**MEMORANDUM
PLACER COUNTY
PLANNING DEPARTMENT**

TO: Lori Lawrence
FROM: Gina Langford
DATE: October 5, 1999
SUBJECT: Bickford Ranch DEIR

The Planning Department has the following comments on the DEIR. These include mostly minor editorial corrections as indicated on the enclosed cut sheets.

RESPONSE TO COMMENT LETTER C1

OPEN SPACE AREAS SUBJECT TO FUEL REDUCTION MEASURES

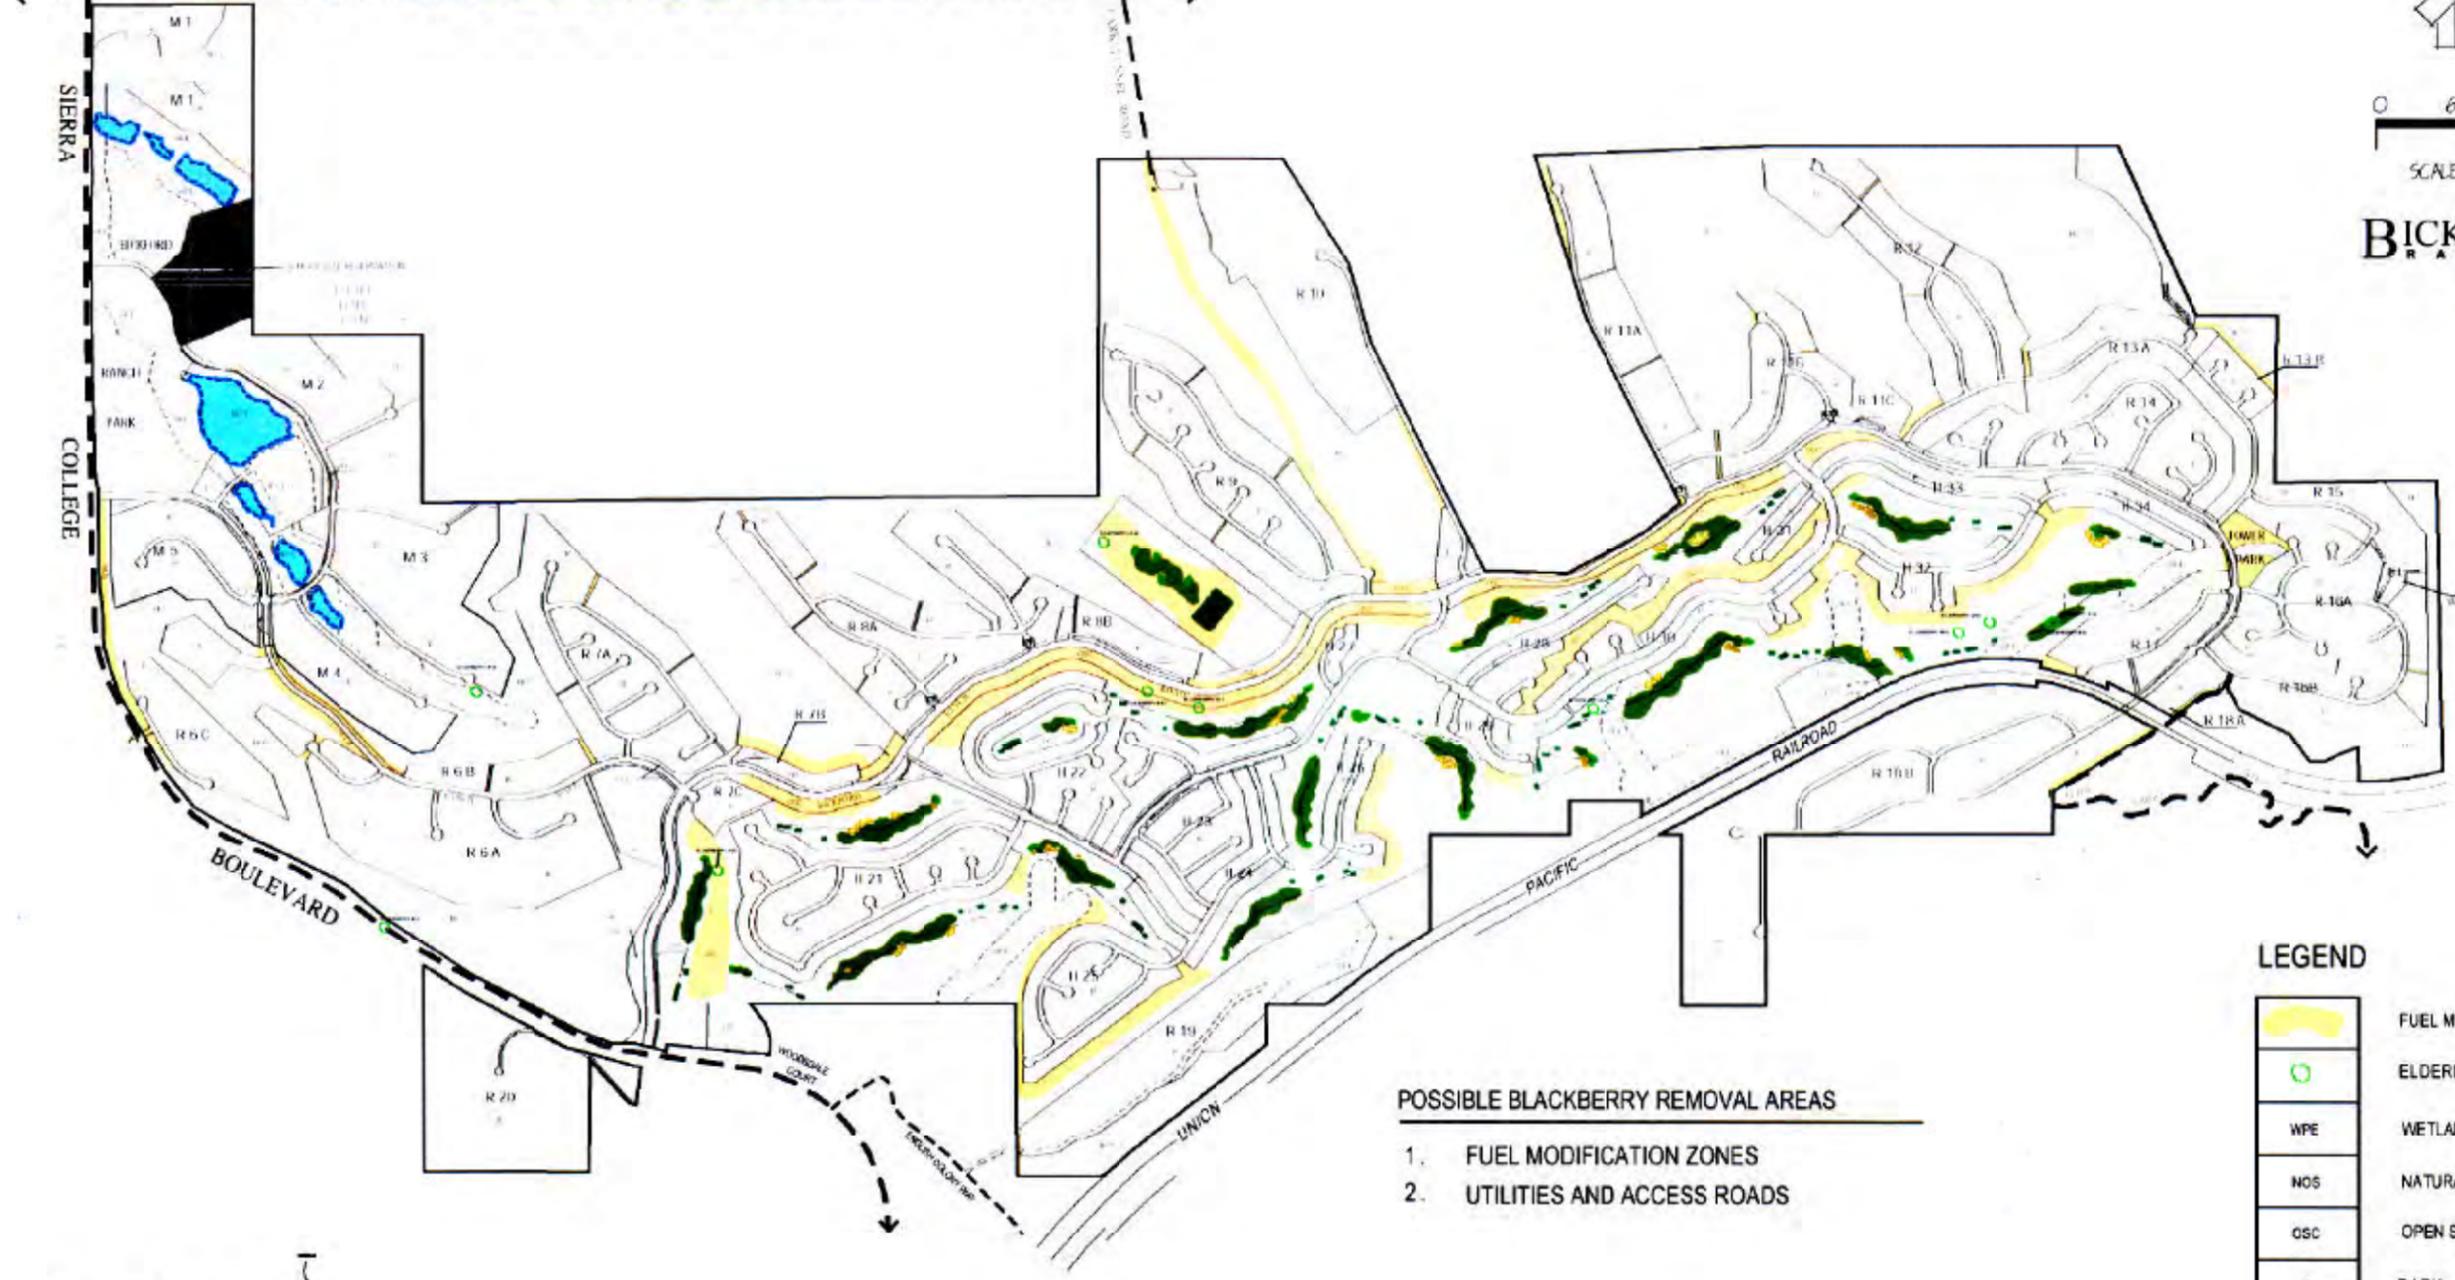
Gina, attached please find proposed language for fuel reduction on the Bickford Development. The large open spaces in this project pose a potential significant wildland fire threat. In that regard, the attached outlines a fuel reduction methodology to reduce the hazard to less than significant. At the same time, this methodology will provide unaffected open space areas for natural and wildlife habitat.

Response C3-1: The commentor has worked with the Applicant to revise the proposed language for fuel reduction on the project site. The revised language is attached to the Commentor's later letter of January 13, 2000, attached following the DEIR comment letter. As noted in the letter, Placer County staff and the Applicant agree to the revised language. The open space areas subject to fuel reduction measures are shown on Figure C3-1, and the open space fire access areas are shown on Figure C3-2. The "modified shaded fuel break" prescription described in the fuel reduction measures is shown schematically on Figure C3-3.

FIGURE C3-1

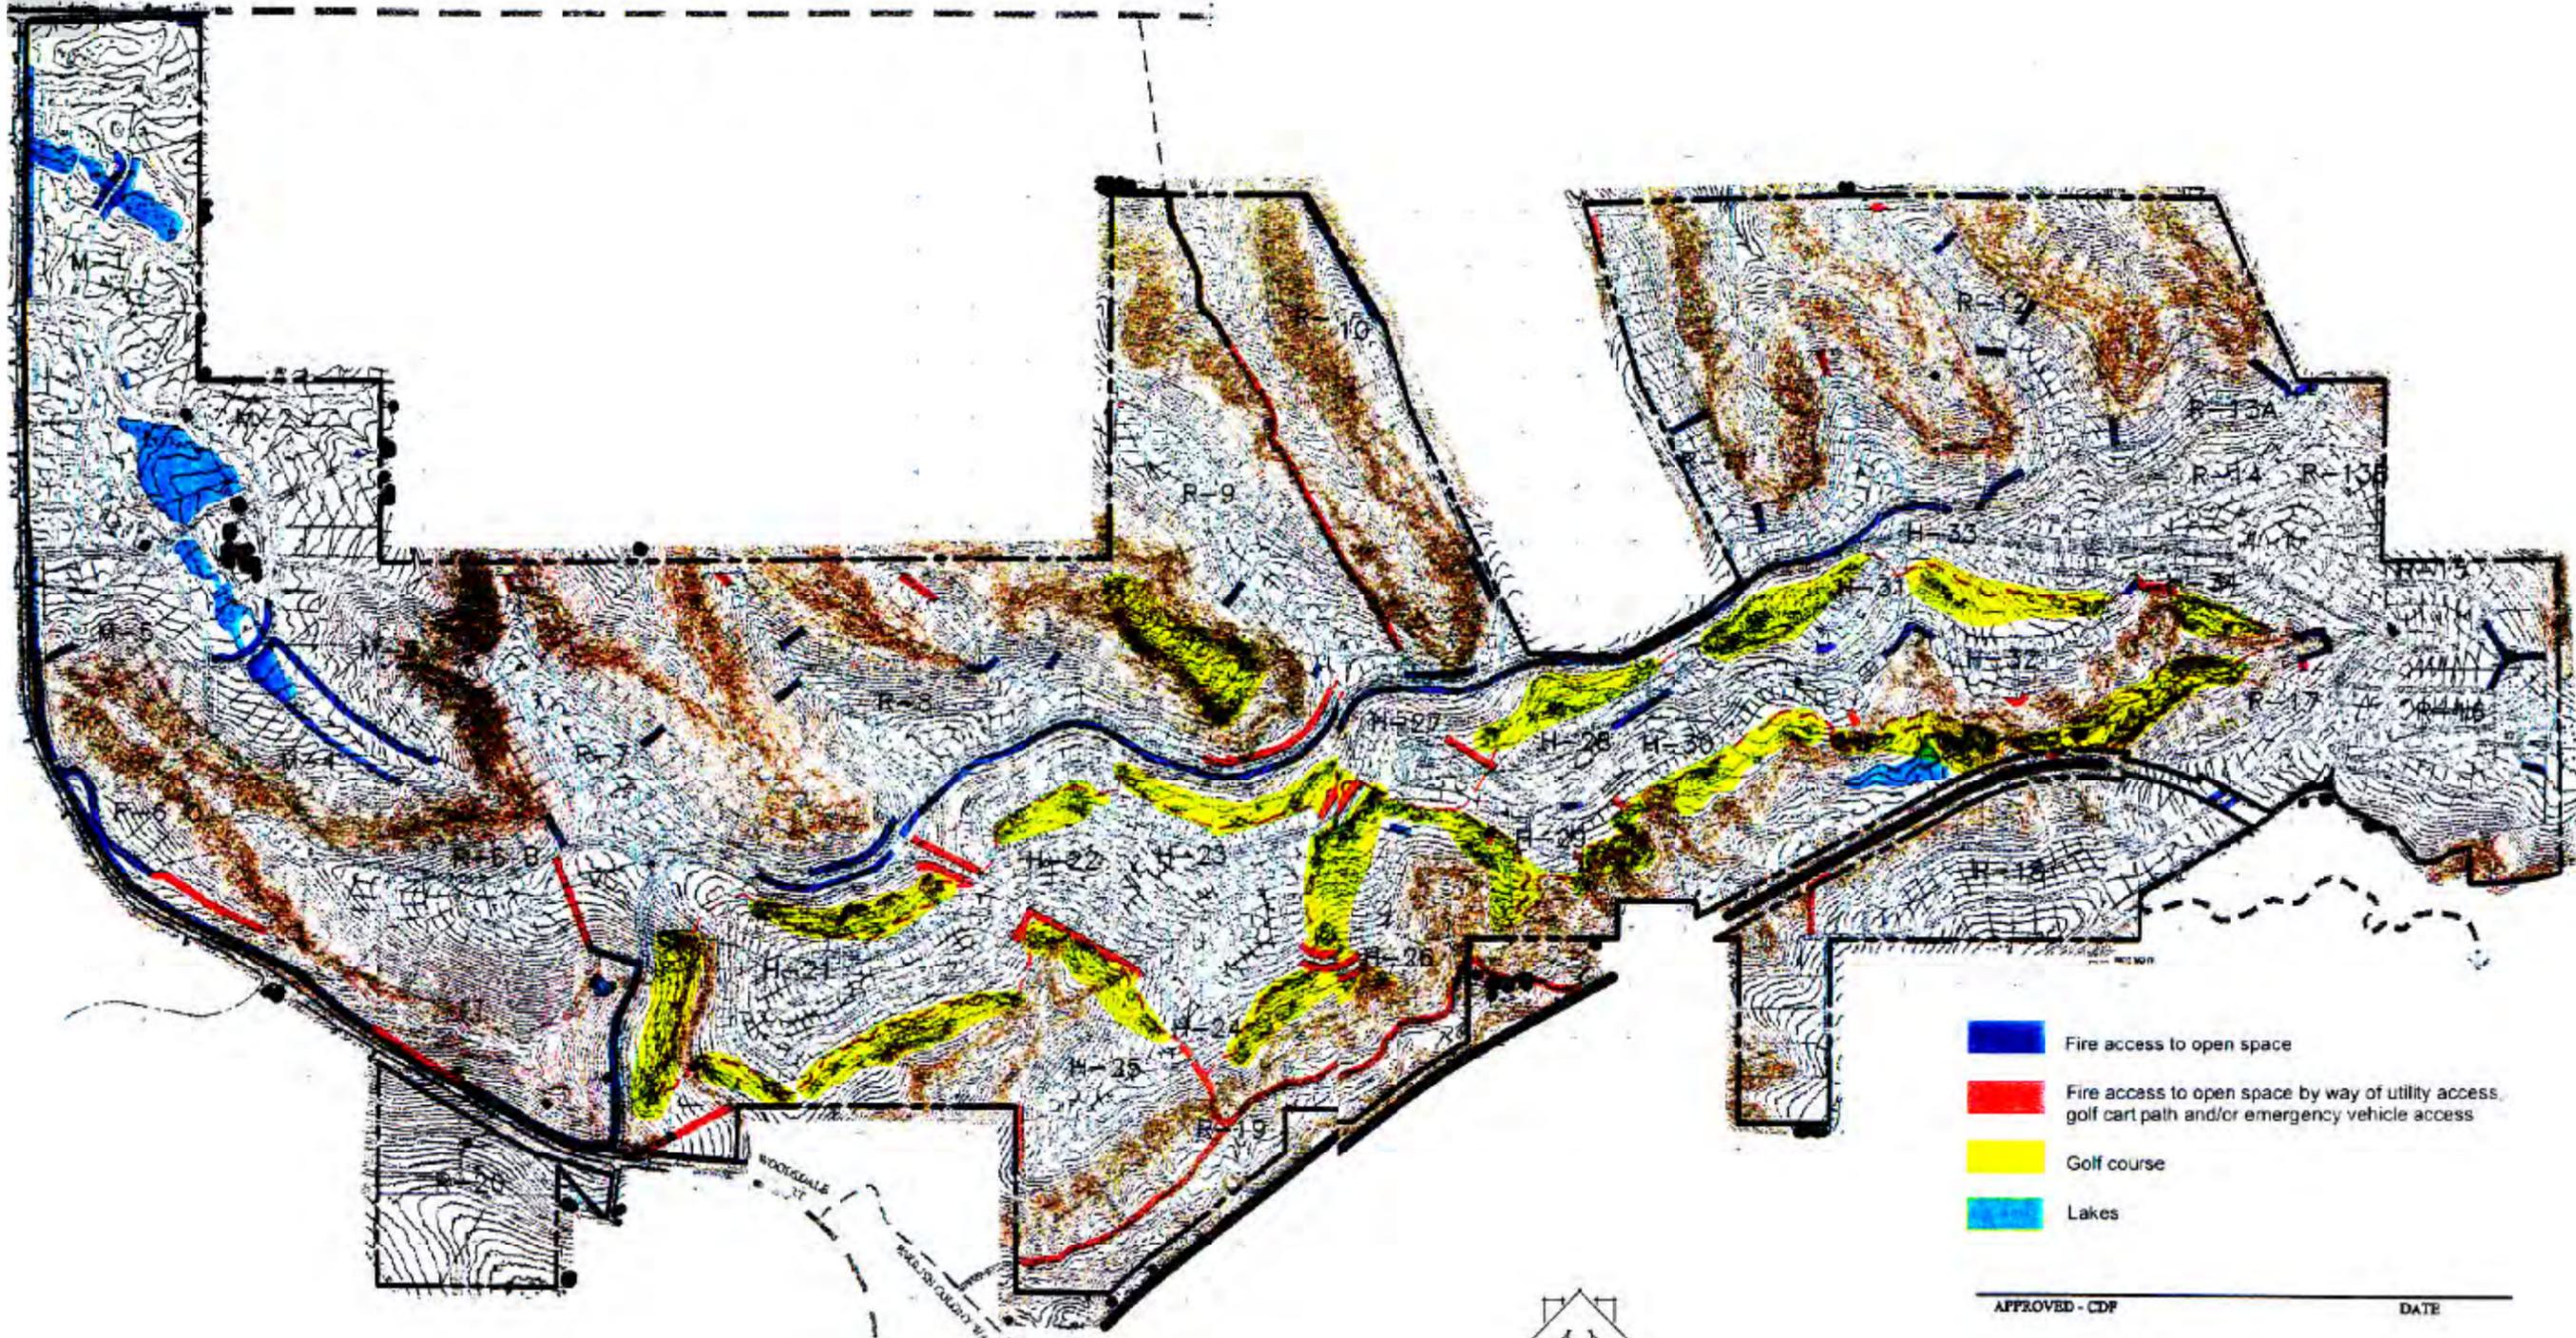
4. All accesses designed into the open space or common areas of a subdivision, shall be made accessible by a 15 foot wide unobstructed fire access lane. The fire access lanes shall be constructed as shown and approved by the California Department of Forestry and Fire Protection (CDF) and the Placer County Office of Emergency Services/Placer County Fire Department on "The Open Space Fire Access" exhibit dated 7/13/99. Utility/Fire access lanes shall be made accessible by a 12 foot wide all weather surface. Emergency vehicle access roads shall be made accessible by 18 foot wide all weather surface roads. Access from each cul-de-sac when adjacent to open space or common area shall be provided as approved by CDF. The "Open Space Fire Access" exhibit dated 7/13/99 and approved by CDF and the Placer County Fire Department meets these requirements.
